**REQUEST FOR COMPETITIVE SEALED PROPOSALS  
TO REPLACE HVAC CHILLER AT THE DISTRICT'S  
TECHNOLOGY DATA CENTER**

**Addendum No. 02**

## Addendum 02

260018.000 | Tomball ISD-Chiller Pkg 1-Tech Bldg

**Item 01**      **Sheet M2.11 –MECHANICAL PLAN – CENTRAL PLANT**

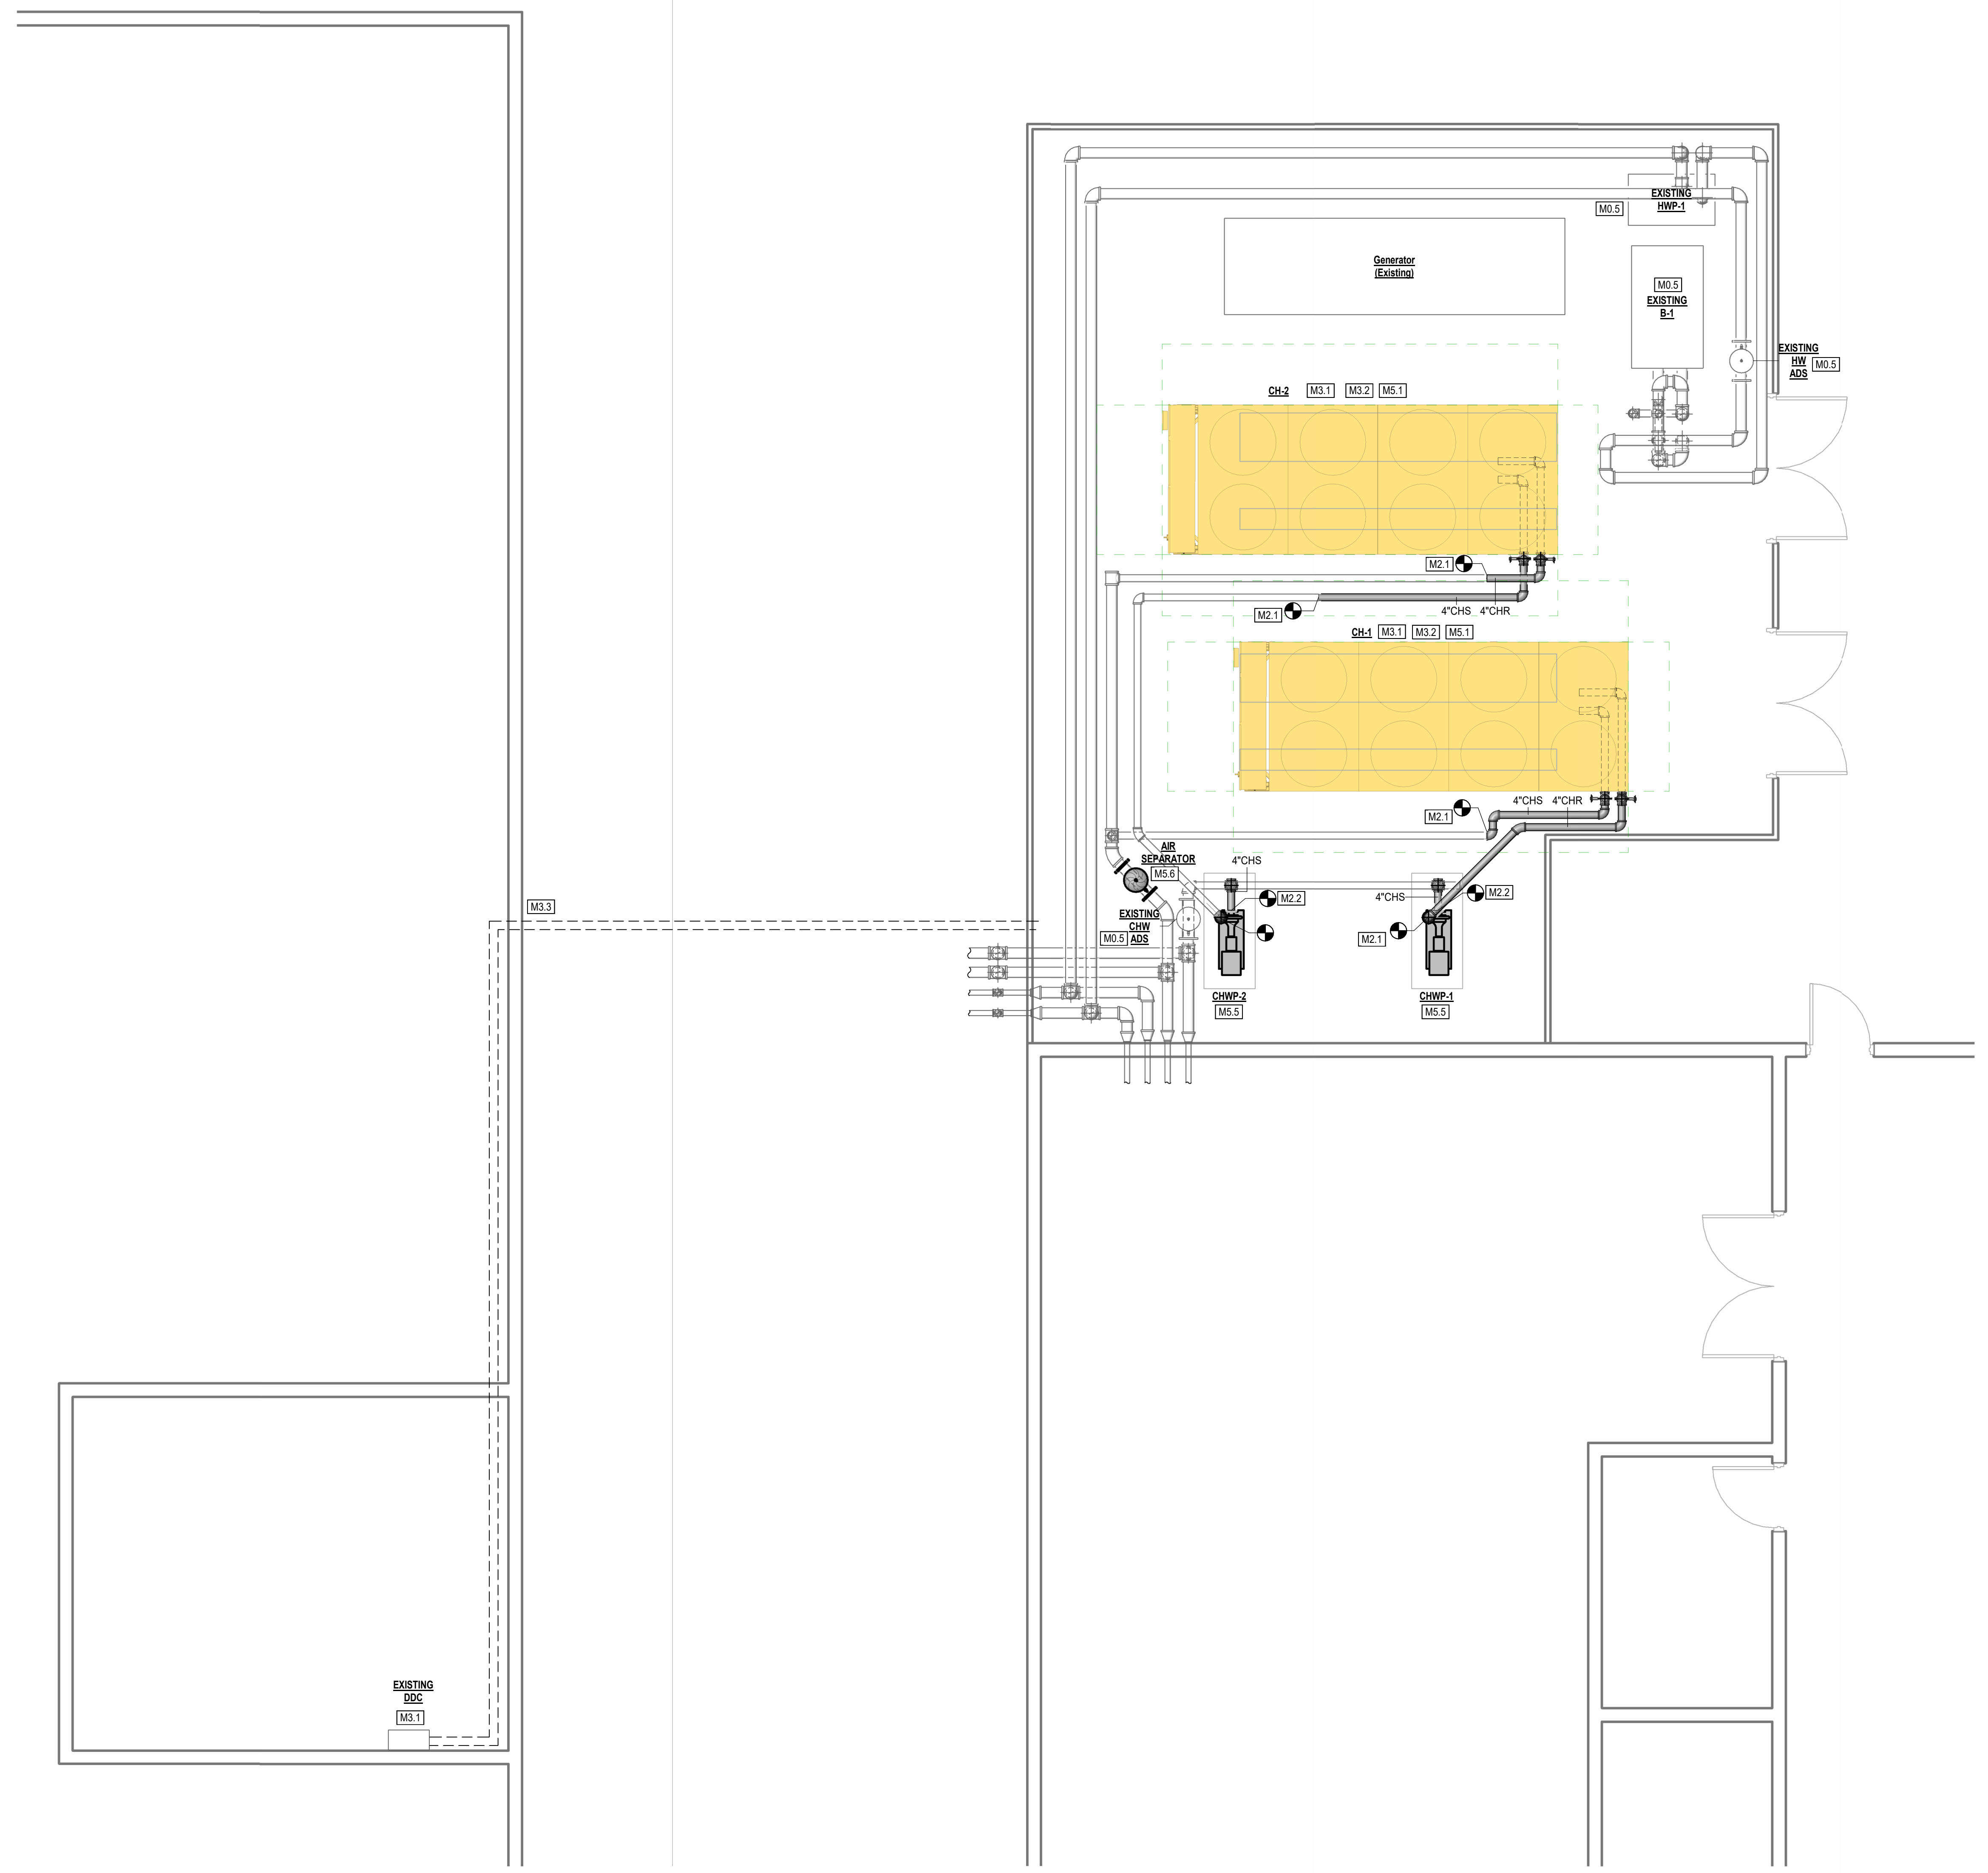
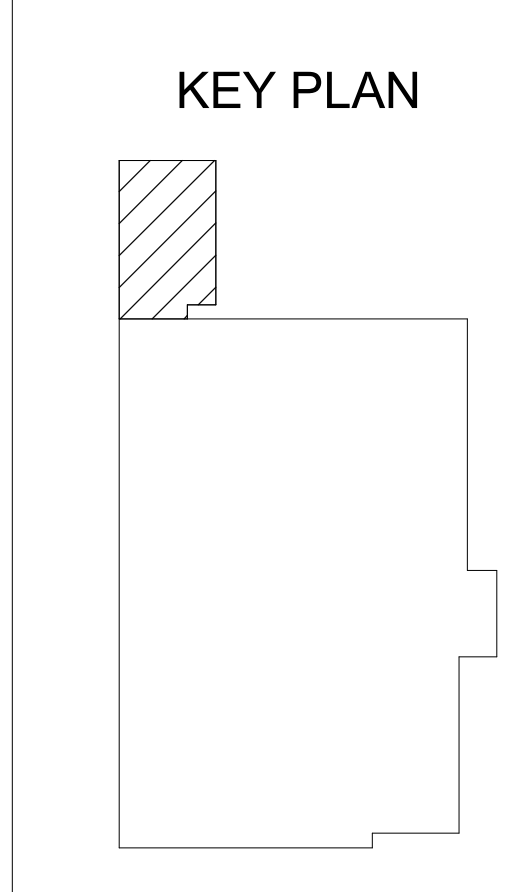
- A.      Revised keyed note M5.5 to clarify pump inertia base scope.
- B.      Revised keyed note M5.6 to provide air vent as part of Alternates 1B and 1C in lieu of Alternates 2B and 2C.

- M5.5 PROVIDE END SUCTION PUMP, ASSOCIATED INERTIA BASE, AND ASSOCIATED ACCESSORIES AT APPROXIMATE LOCATION SHOWN. INSTALL PER MANUFACTURER'S WRITTEN INSTALLATION INSTRUCTIONS. INSTALL ON EXISTING CONCRETE HOUSEKEEPING PAD. EXTEND EXISTING PAD AS NECESSARY. PUMP REPLACEMENT AND ASSOCIATED WORK TO BE AS PART OF ALTERNATE 4. RE: DETAIL 4M5.01.

- M5.6 PROVIDE AIR SEPARATOR WITH AUTOMATIC AIR VENT (BELL & GOSSET R-8F OR APPROVED EQUAL) AT APPROXIMATE LOCATION SHOWN AS PART OF ALTERNATES 1B AND 1C.

**Item 02**      **Sheet M5.01 - MECHANICAL SCHEDULES AND DETAILS**

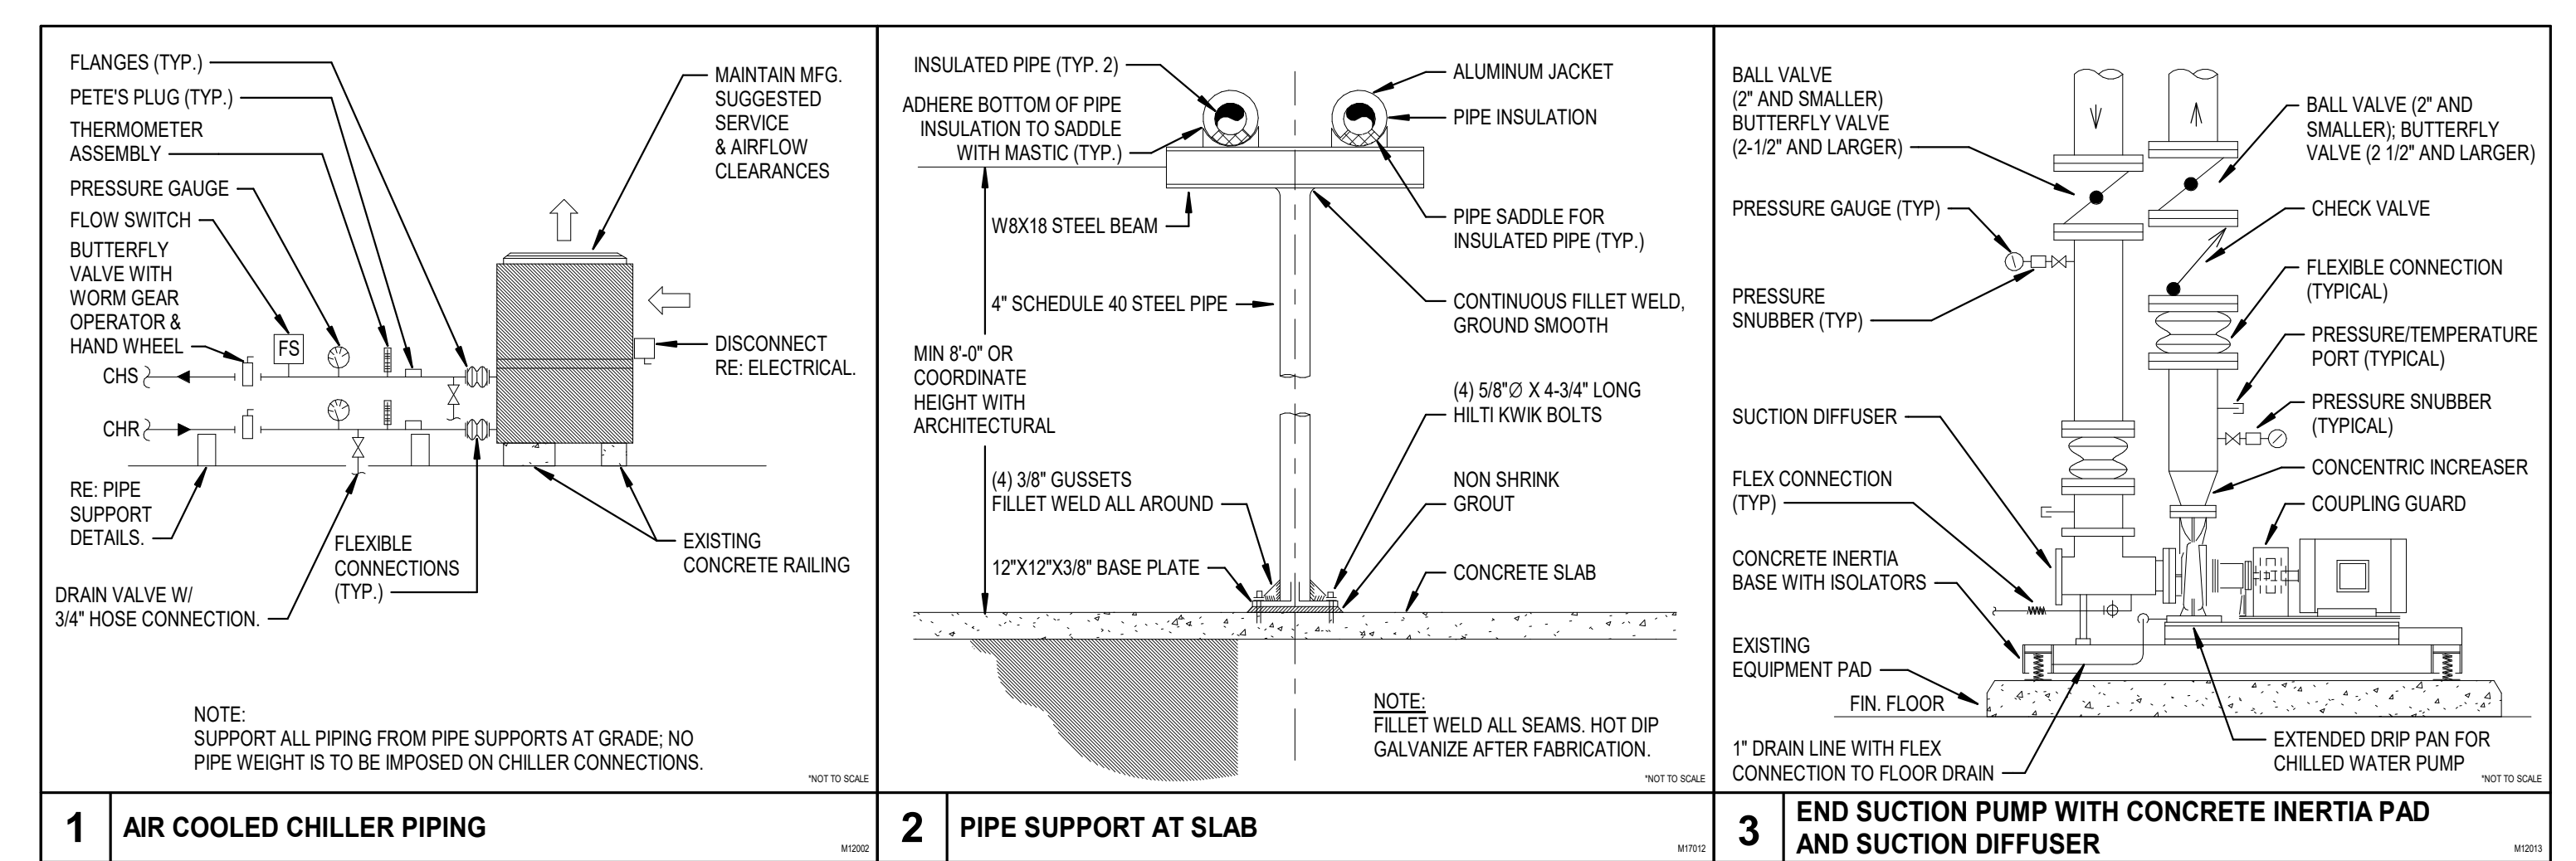
- A.      Added Pump Schedule note to clarify inertia base scope.

NOTES:  
1. PUMP SHALL BE NON-OVERLOADING ACROSS ENTIRE GPM RANGE.  
2. PROVIDE WITH PREMIUM EFFICIENCY TEFC MOTOR FOR OPERATION WITH EXISTING PUMP STARTER.  
3. PUMPS TO BE RESACED AS PART OF ALTERNATE 4.  
4. PROVIDE WITH NEW INTERIA BASE. TRIM/EXTEND EXISTING CONCRETE PAD AS NEEDED.
